Regarding: FCC Class II Permissive Change
FCC ID: 2AVNR-RPI3BP

We, Noiseless Acoustics Ltd. hereby declare that the intention of this Class II Permissive Change is to change the grant from mobile module to portable module in order to authorize the module for use in a handheld device. We have done some hardware modifications to the module for integration purposes, although, they do not involve the RF circuitry.

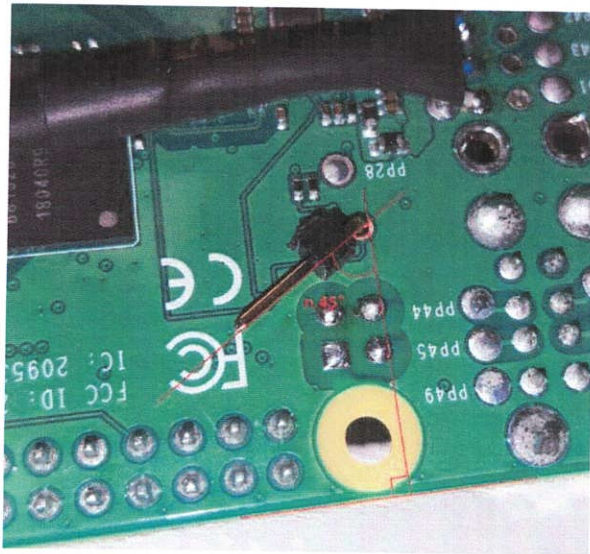
- 2. added cable to the pads of the connector J11

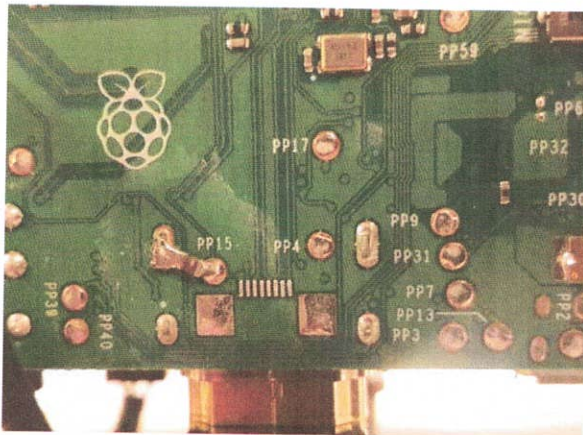
- 3. added header for the RUN-signal to its designated place

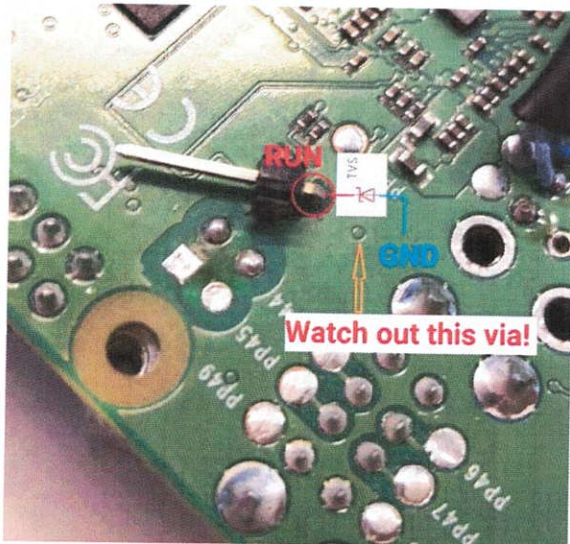
- 4. added signal protection components to RUN signal.

The capacitor will be soldered to PP15 and GROUND-pin nearby

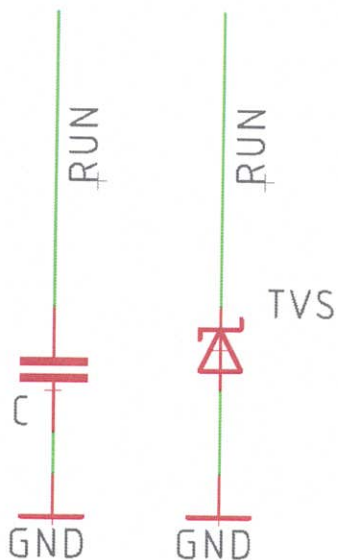
The placement of the TVS diode nearby the pin header
